MASTER DEVELOPMENT DRAINAGE PLAN

THE RETREAT AT TIMBERRIDGE

FOR COMMENT

PUD-17-00 3

DETENTION BASIN STAGE-STORAGE TABLE BUILDER

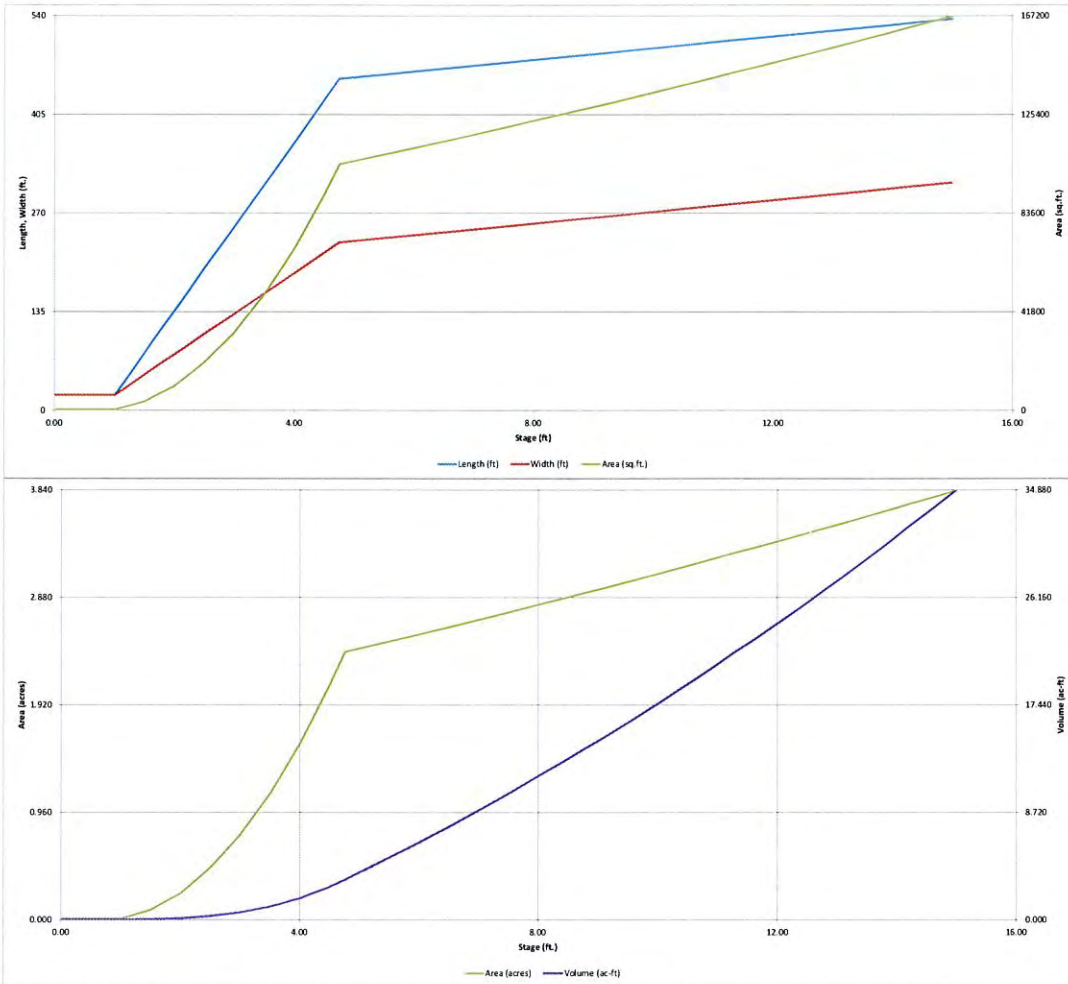
Should this be closer to 50%? Offsite flows should be provided with a bypass conveyance.

THE RETREAT AT TIMBRIDGE
 MASTER DEVELOPMENT DRAINAGE PLAN
 PRE-DEVELOPMENT DRAINAGE MAP

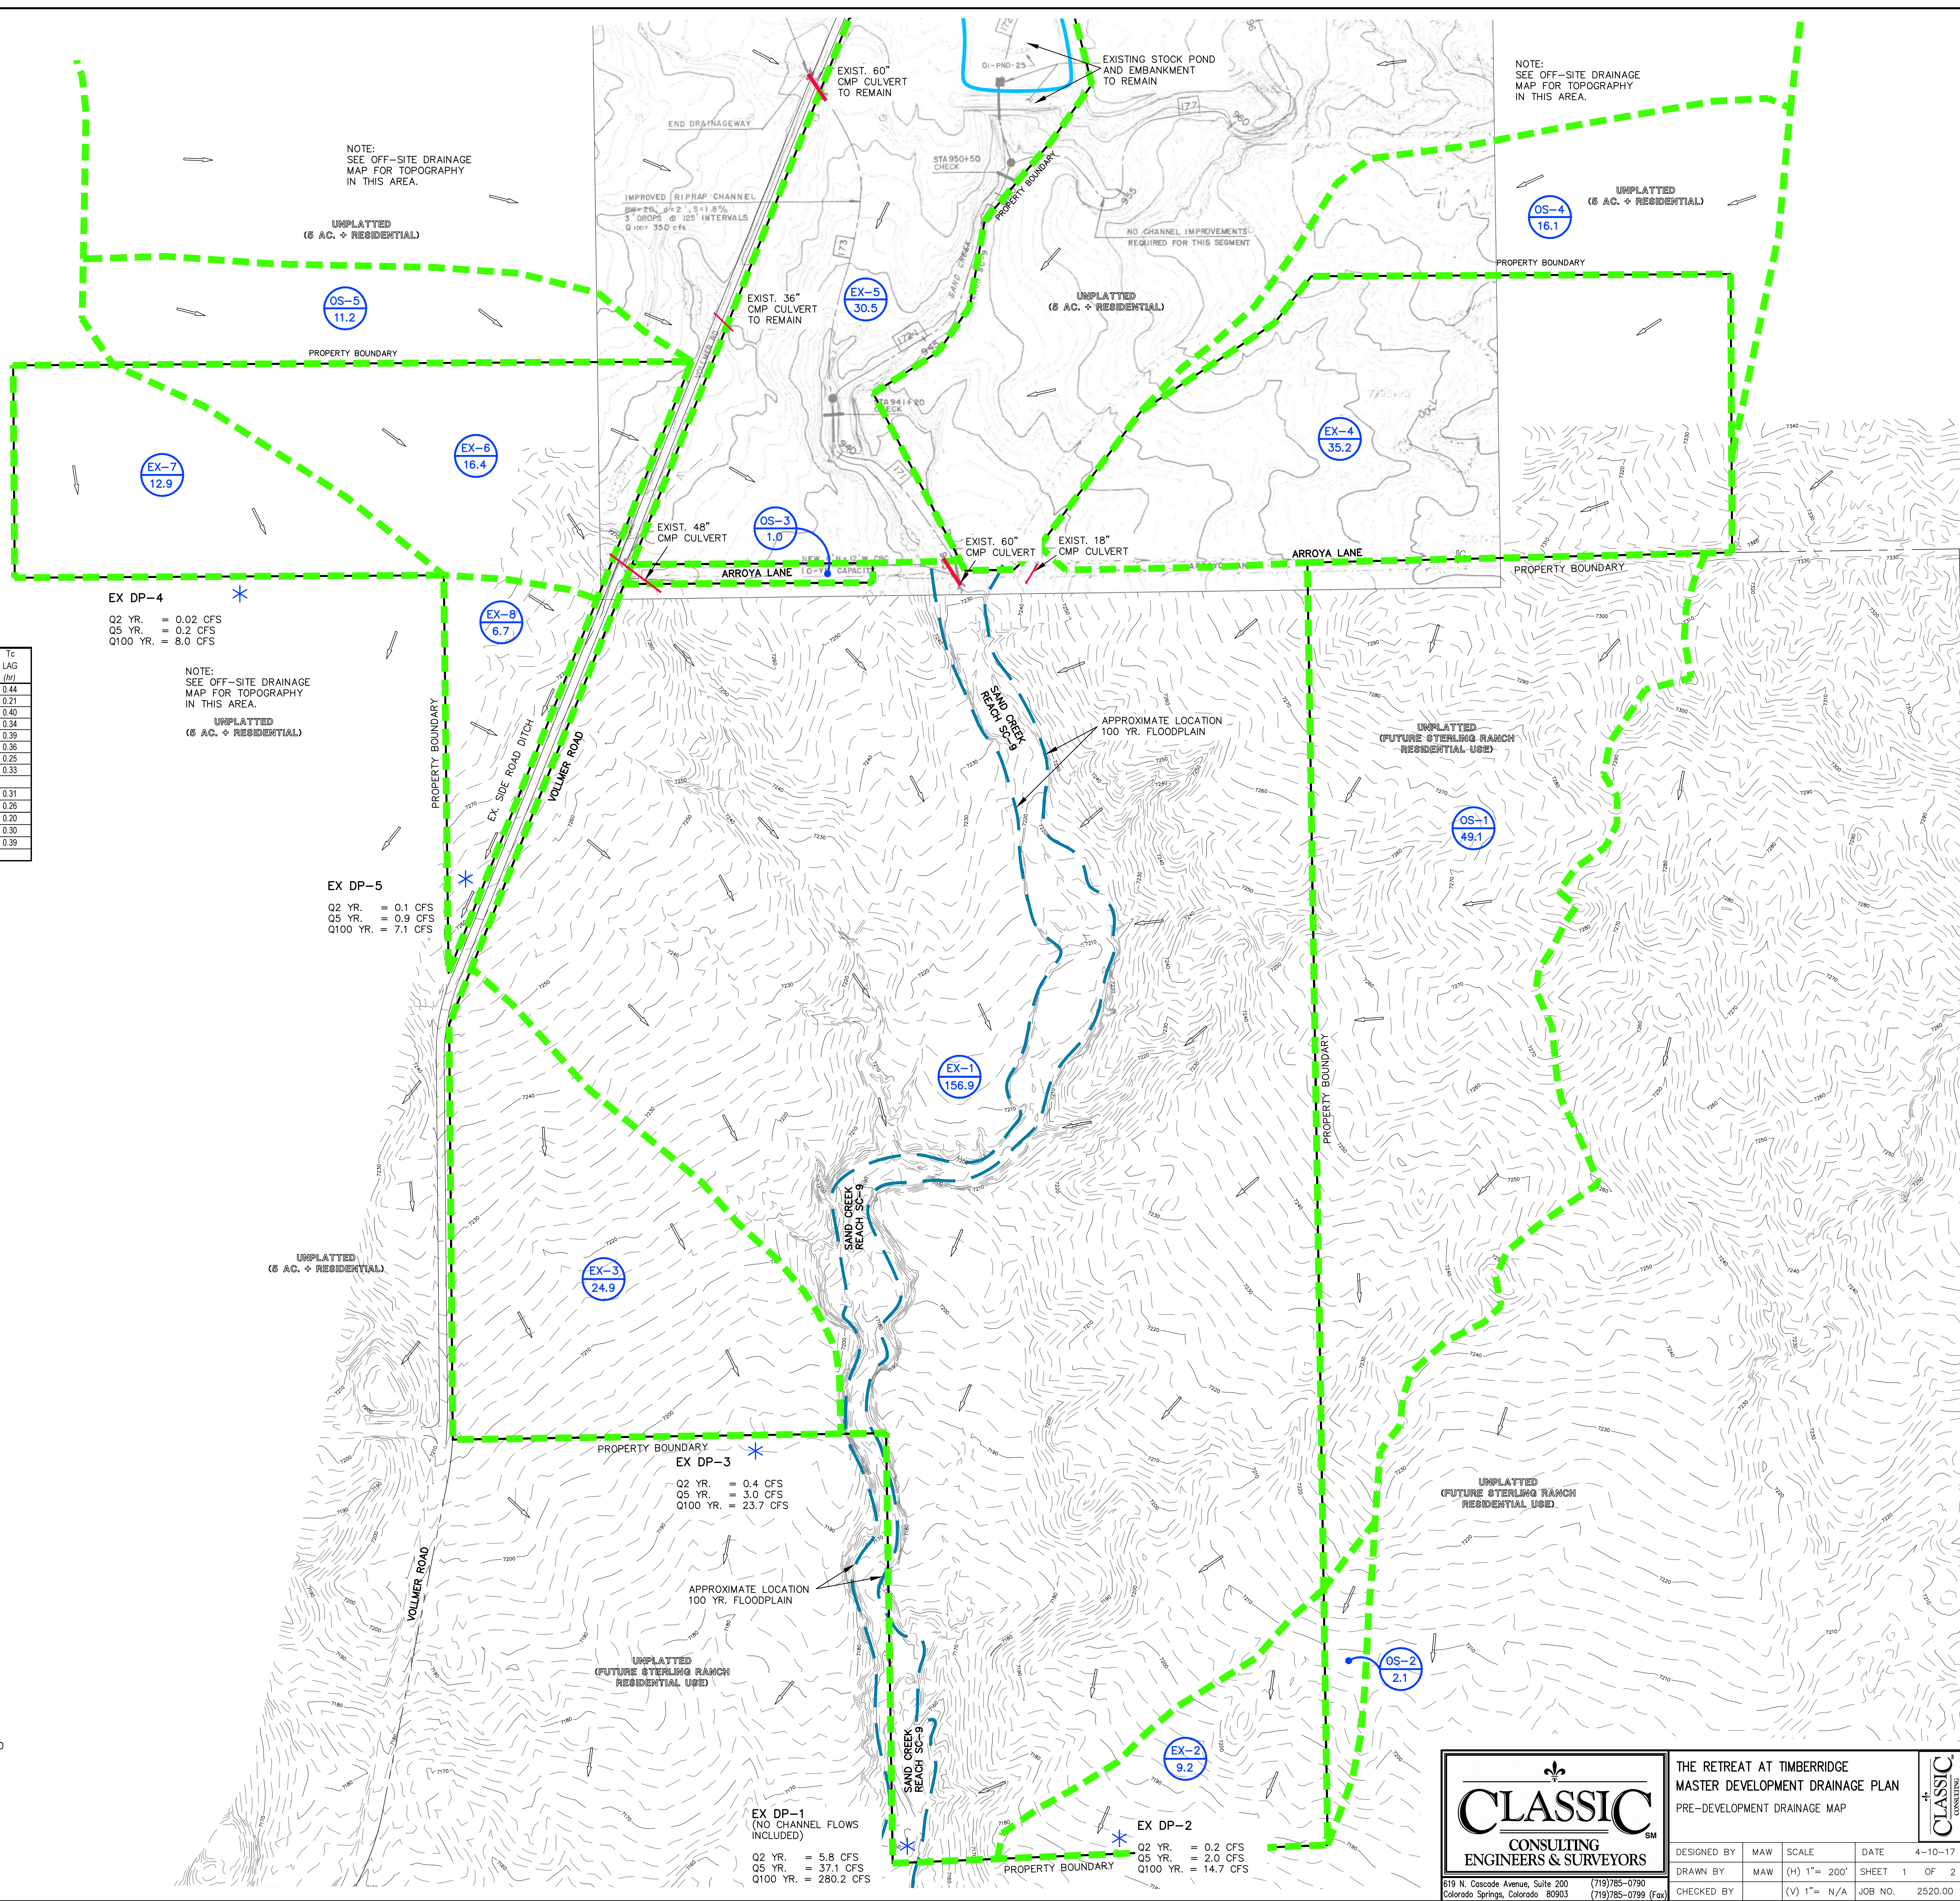
Label Sand Creek DBPS flows upstream and downstream of the development. (also on existing conditions plan)

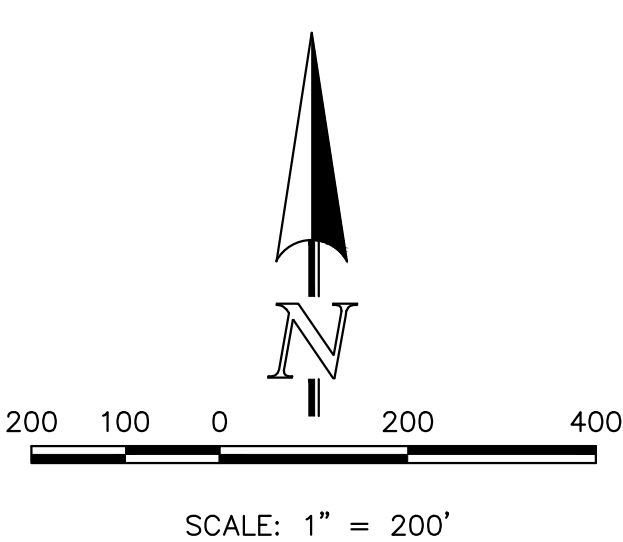
Sub-basins OS-1 and OS-2 are not all sheet flow. Provide a method of capturing these offsite flows and conveying them downstream. Drainage easements along the east property line and possibly between the proposed lots are necessary to accommodate the conveyance(s).

Show the conceptual storm drain system conveying flows to the proposed detention ponds.
